RECOMMENDATION MEETING
ADMINISTRATIVE DESIGN REVIEW

SDCI # 3025989 - LU
8105 Greenwood Ave N
& 8111 Greenwood Ave N

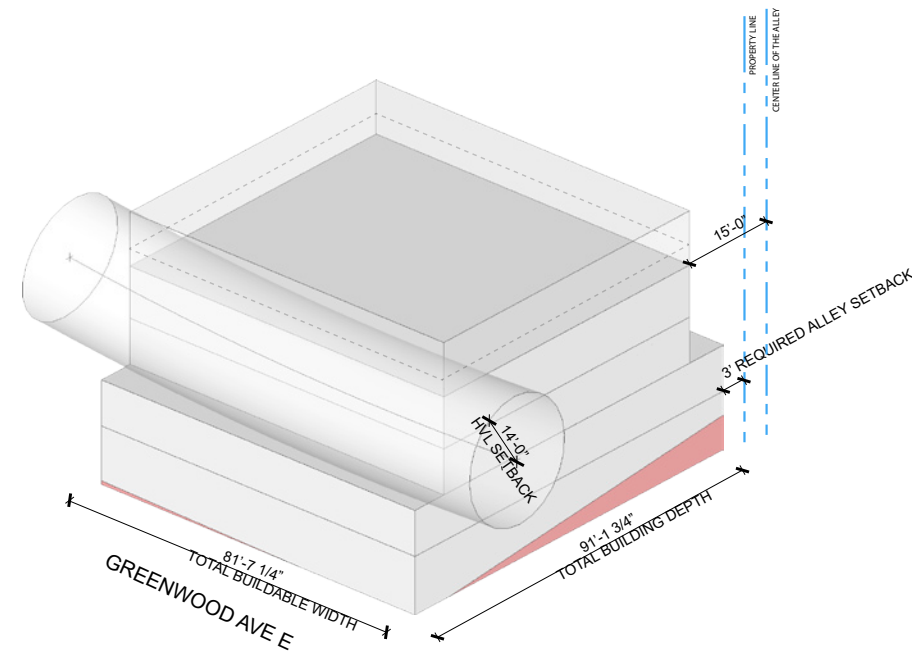
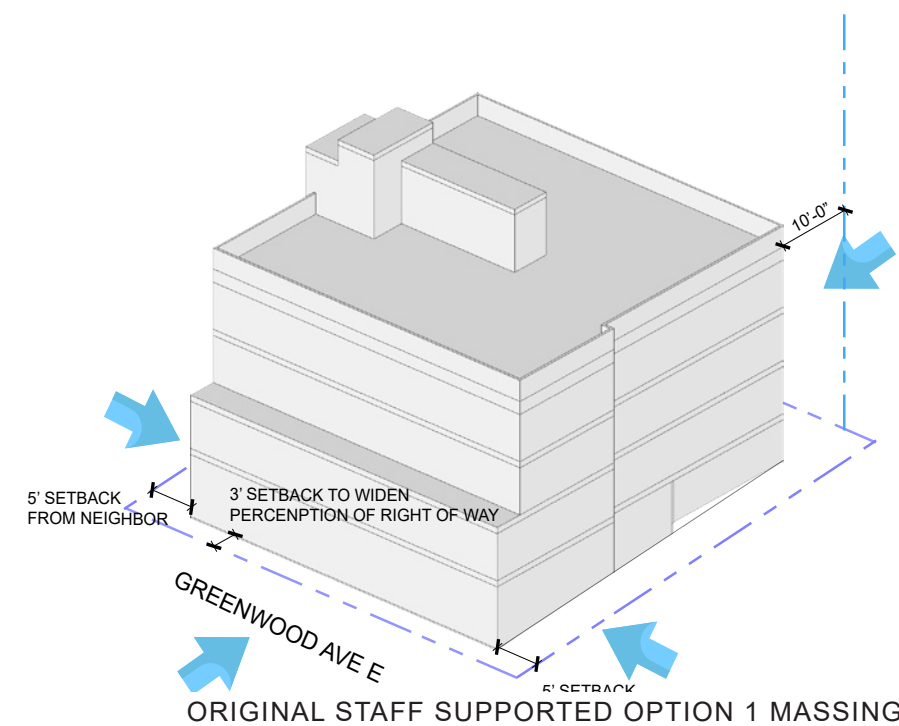
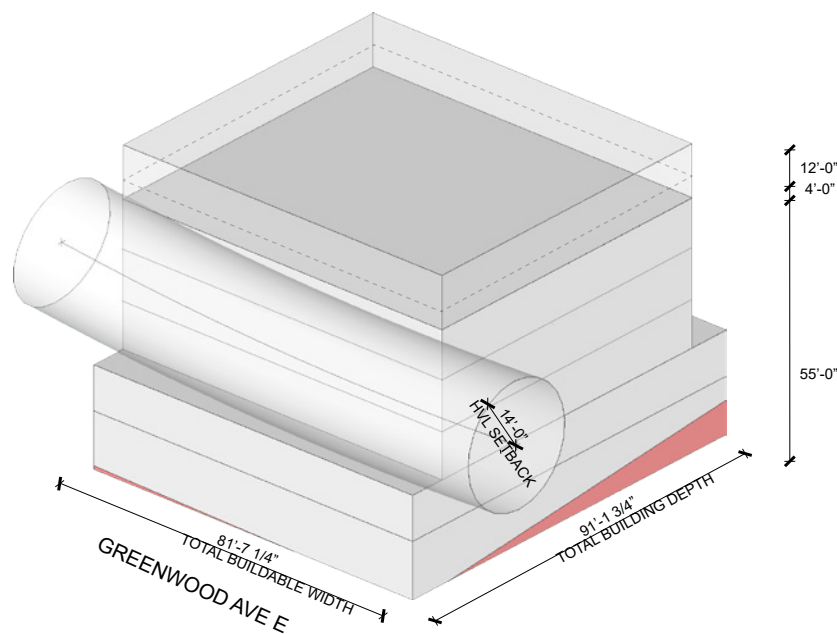
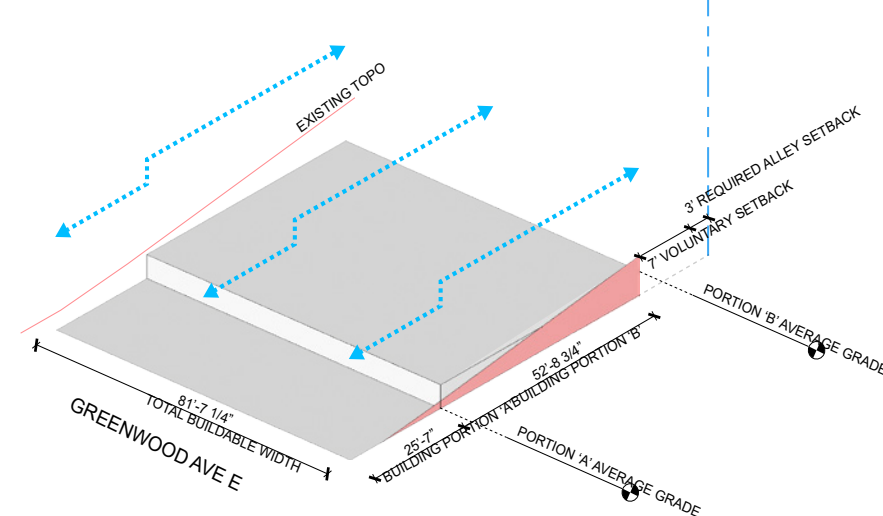
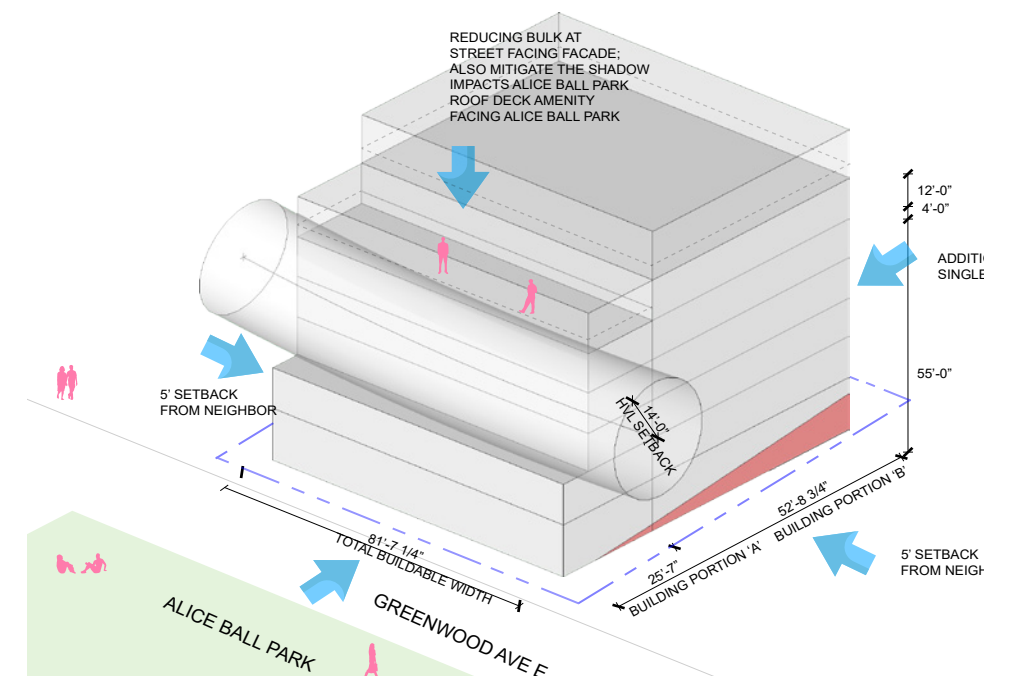
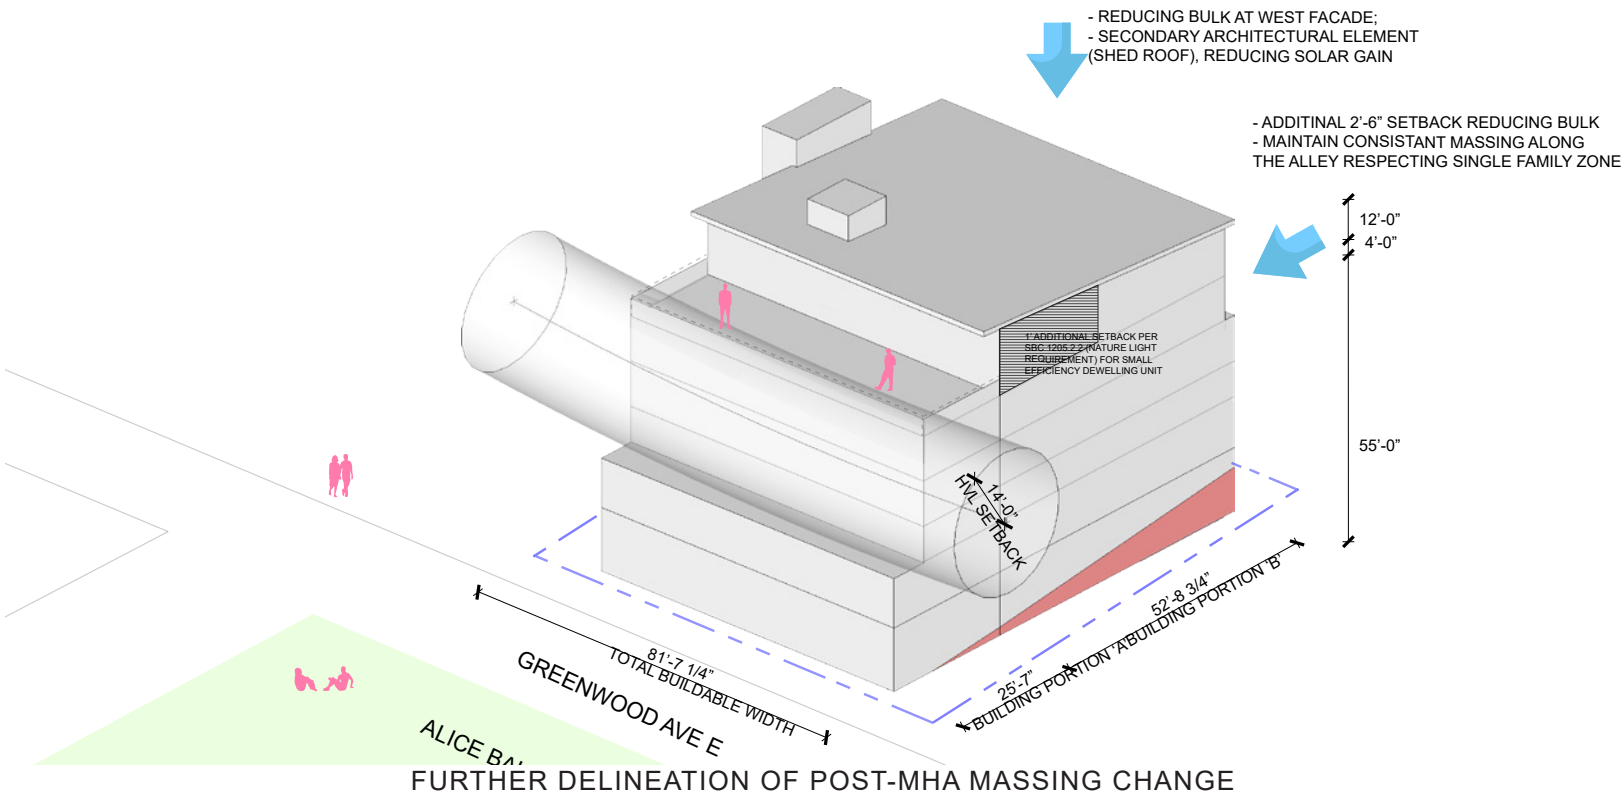
1. Massing: SDCI Staff considered the three massing alternatives, which are similar in scale, but differ in how the bulk of the structure is located on the development site. SDCI review was primarily focused on how the alternatives relate to the existing and the future scale along Greenwood Avenue N, a pedestrian designated street. Staff supports the uniform two-story massing along Greenwood Ave N as provided in Option 1. The two-story massing responds well to the existing two-story datum line directly south. Level three and four setbacks transition well and respond to the sloping site topography. The three-story massing along the alley is consistent with the scale allowed in the adjacent single-family zone.

We took the guidance that we have received from the EDG report, and further developed Option 1 with the most recent MHA zoning change. As the massing evolution diagram below shows, we have kept the uniform two-story massing along Greenwood Ave N, as well as the upper level setbacks to respond to the sloping site topography. To be sure, due to the extra structure height afforded under the new zoning designation, the overall building has increased in scale. At the alley, this has resulted in two more floors than were previously shown in the EDG packet. Noting the SDCI staff support for three stories at the alley, we have stepped the building back at this datum and provided a roof overhang to cap the building in a more residential manner.

POST MHA DESIGN - AXON VIEW

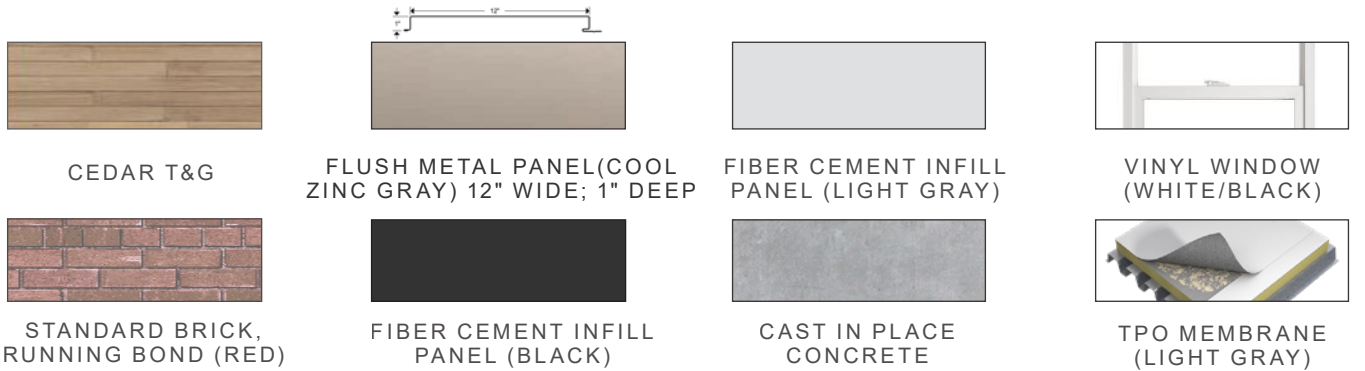
2. Façade Composition and Materials: Staff supports the use of fenestration, material choices and changes, and secondary architectural elements to provide depth and visual interest to the building façades, while also relating to the existing neighborhood context. Further develop a simple, neutral, background building with moderate architectural presence across from the park and public library.

- a. Materials. Staff recommends utilizing a material palette consisting of high quality materials. Materials on the upper and lower levels should be complementary to each other and to the general character along Greenwood Avenue N. The success of the proposed massing is contingent on plane changes that are reinforced with a change in material and high quality detailing.

High quality materials were selected to reinforce neighborhood context at large as well as design moves within the project. In response to the EDG, red brick is proposed as the predominate brick color in the neighborhood and to relate to the library located across. Complimentary high quality materials at the street facade include cool zinc gray flush metal panels oriented vertically and large panel sliding doors and Juliet railings as a practical secondary architectural feature. Tongue and groove cedar is proposed at the vertical building notches in the building and resolves as a warm and tactile material at the roof deck. At the alley-oriented massing, a quiet and carefully detailed application of fiber cement panels is proposed.

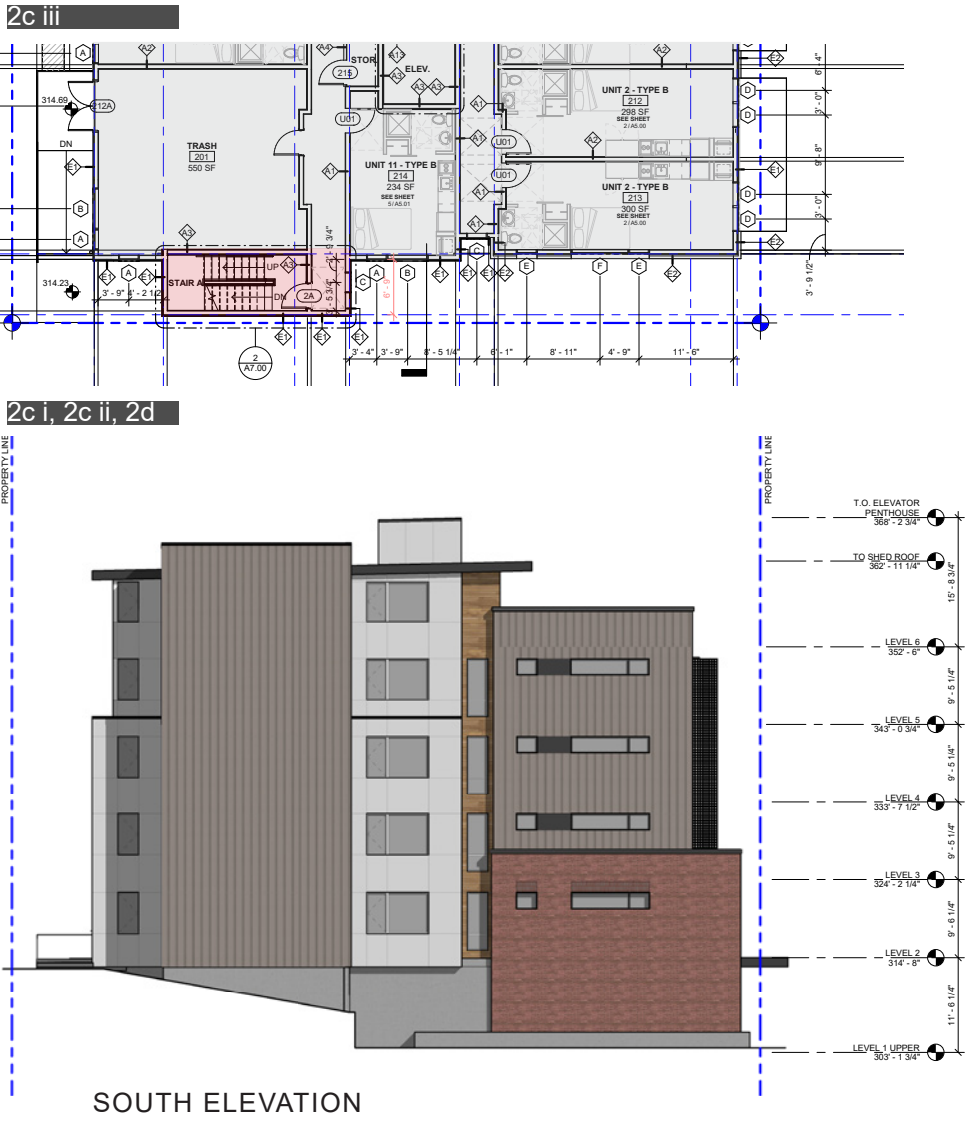
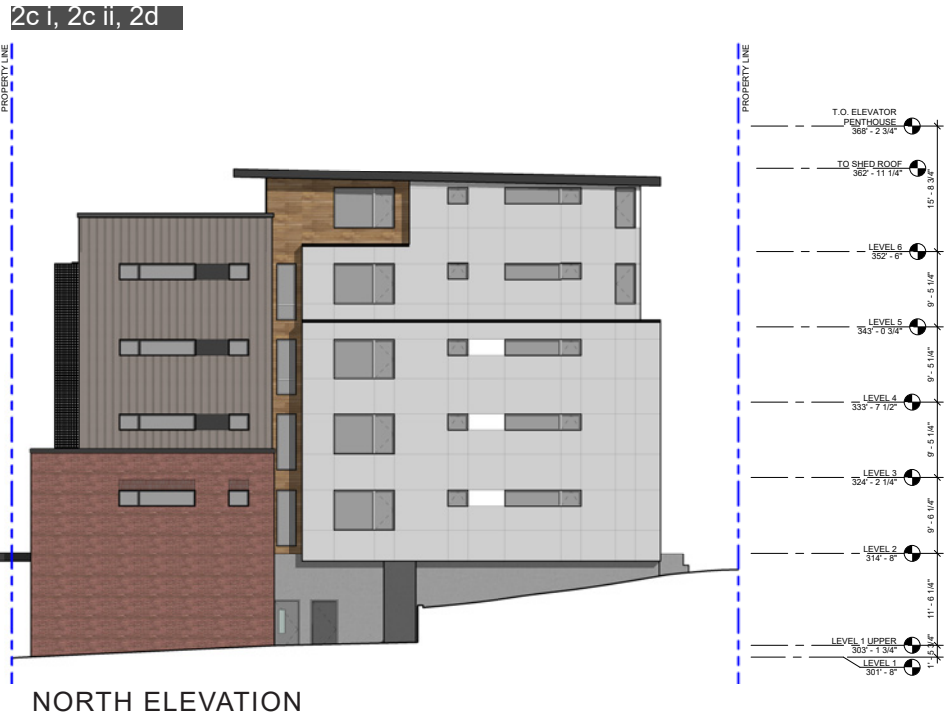
- c. South Façade. Maintain the generous seven-foot setback from the south property line to provide separation between the existing residential windows to the south and the proposed structure.
- i) Wrap the Greenwood materials into the north and south façade setbacks.

ii) Locate south facing windows above floor to add visual interest to the façade and avoid large blank walls, consistent with page 25 rendering. Where possible, include windows on the north façade.

iii) Provide plane change between the south stair tower and the most south-easterly units. Utilize a change in materials to further break down the massing and avoid large blank walls.

APPLICANT RESPONSE:
The building setback at the south property line is now approximately 8'-6" (previously shown as 7'-0")

i) Two stories of brick at the street-facing facade wraps the northeast and southeast building corners and resolves at building notches.

ii) High panoramic windows are proposed for the north and south facades.

iii) The south stair tower is 6'-9" proud of the adjacent south-eastern units and reads as a vertical massing element, rendered in flush metal panels to further distinguish to from the adjacent units.

2d - a, c

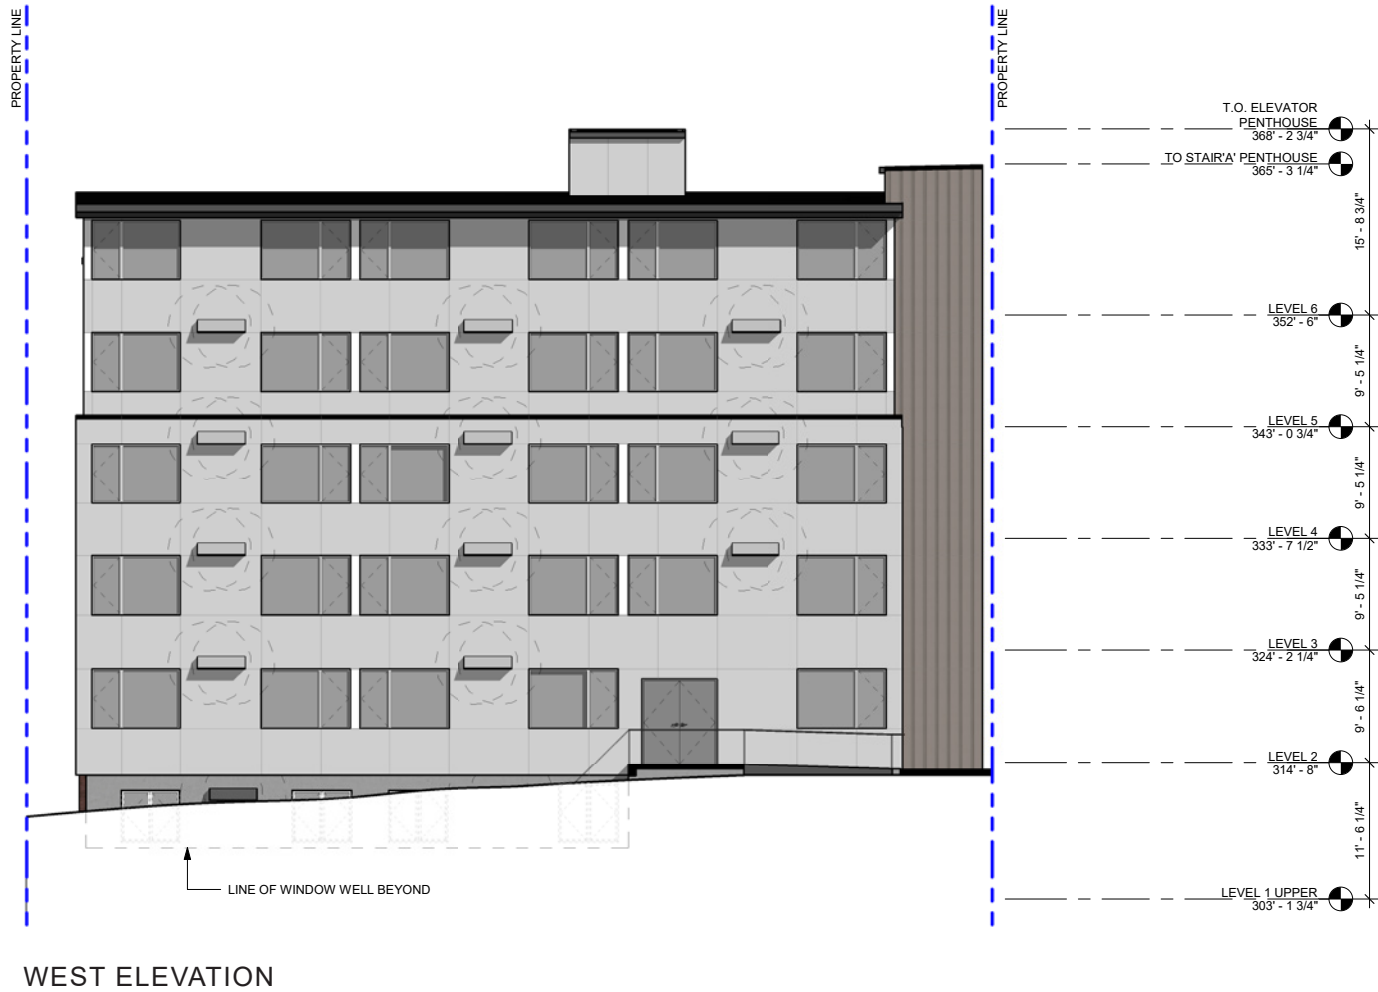
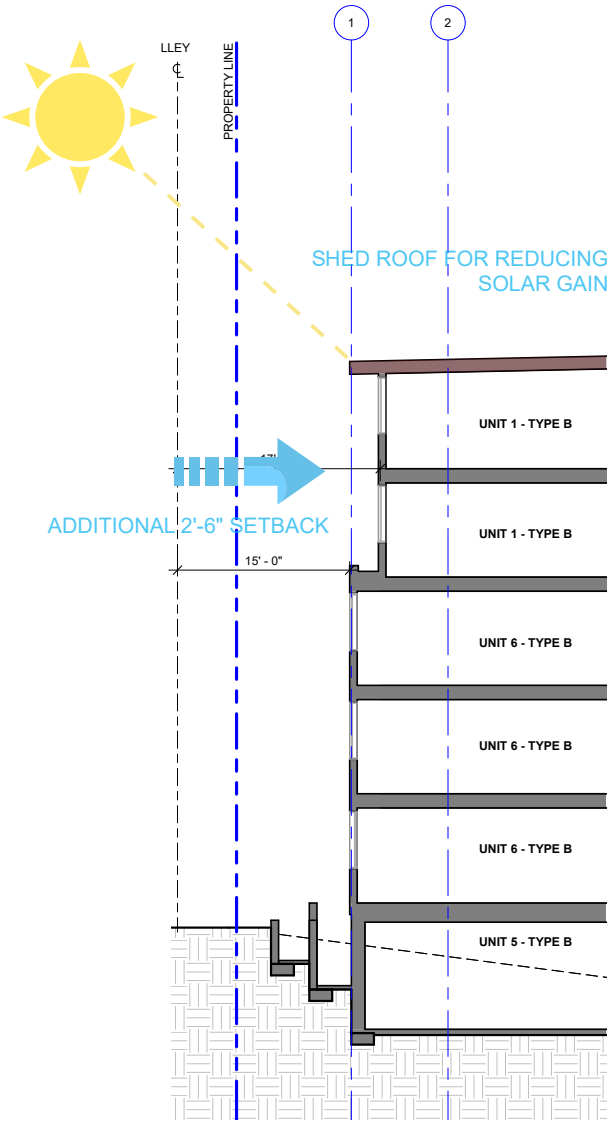
- d. *West Façade.* Design the west façade with restrained fenestration and material treatment sympathetic to single family zone to the west. Consider secondary architectural elements along the west façade to manage solar gain, provide increased privacy, and provide a finer texture facing the single-family zone

APPLICANT RESPONSE:
The west facade has been redesigned with the added available structure height from the recent up-zoning. We have retained well proportioned windows for each unit, consisting of a simple combination of one fixed and one casement window per unit. A shed roof has been added to relate to the more typical sloped roof structures in the nearby single family zone. To help reduce the added height and bulk to the alley-facing mass, we are proposing a setback of 2'-6" above the 4th floor. This setback will reinforce the three-story datum along the alley that was noted in the EDG as more appropriate adjacent to the single-family zone.

2e - west facade privacy study

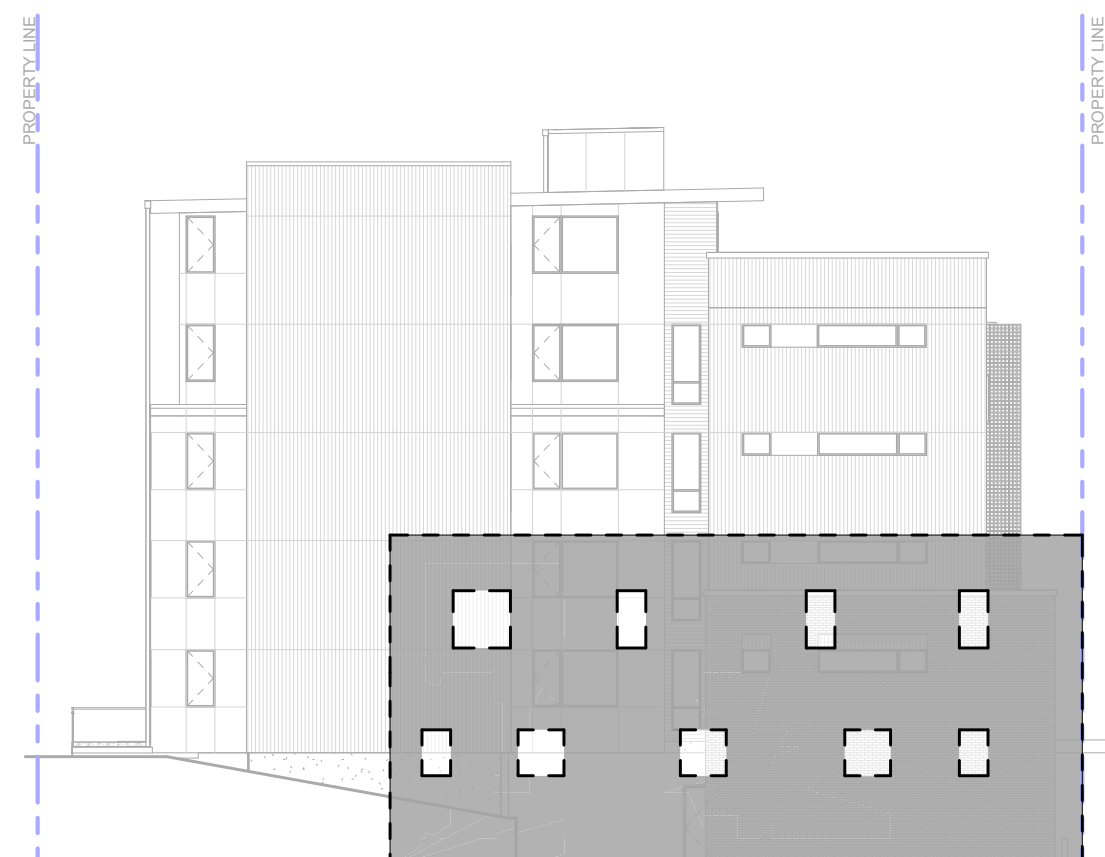
e. Privacy. Provide a window overlay diagram for the south and west facades.

Provided as requested. There are no direct overlaps of windows with the 2-story apartment located directly to the south. Please note that the nearest SFR opposite the alley is some distance away from the project with tall landscaping in between. The garage on the alley associated with this home has 2 windows that have been painted over. Finally, please also note that the neighboring one-story structure to the north (office building) contains no window on its facade facing this development.
